RW SIGNS NO. 5

National Committee on Uniform Traffic Control Devices
TECHNICAL COMMITTEE RECOMMENDATIONS TO NCUTCD COUNCIL

TOPIC: Warning Signs, Two-way Traffic on a Three Lane Road

AFFECTED PORTIONS OF MUTCD: Sections 2C.XX, Table 2C-1; Table 2C-21; Figure 2C-6

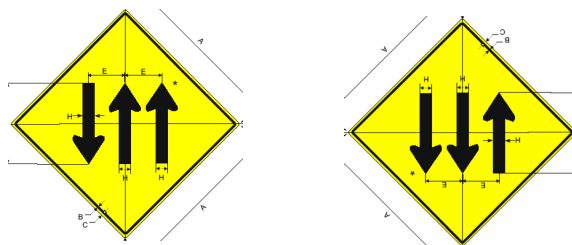
The *Synthesis of Non-MUTCD Signing* identified seventy-four signs or categories of signs that are not in the MUTCD but were in common use by various States, local governments and Canada. The *Synthesis of Non-MUTCD Signing* recommended that these signs be considered for inclusion in the NCUTCD. One of these signs was the symbol “Two-way Traffic on a Three Lane Road” shown below.

At least 3 States are using a variant of the W6-**13** two-way traffic symbol for warning of two-way traffic on roads having three lanes, with one lane in one direction and two lanes in the other direction. The standard W6-**13** symbol shows one up arrow and one down arrow. The three States' variants show three arrows, symbolically denoting not only two-way traffic but also how many lanes in each direction. The Canadian equivalent of the W6-**13** symbol includes a vertical broken line separating the up and down arrows, and one State's 3-arrow variant uses the same concept (but with a solid line) to reinforce the message.

Recommendation: This type of sign with 3 arrows (2 up/1 down or 1 up/2 down) should be considered for addition to the MUTCD, for use on 3-lane undivided roads only.

Add Section 2C.XX, and add sign shown above to Table 2C-1, Table 2C-2 and Figure 2C-6

Section 2C.XX Two-way Traffic on a Three Lane Roadway (W6-X) sign

The Two-way Traffic on a Three Lane Roadway (W6-Xa and W6-Xb) signs may be installed ~~in advance of and at intervals~~ along three lane roadways with two lanes in one direction and one in the opposing direction.

~~Where used, t~~ **The W6-X sign shall match the lane configuration of the roadway.**
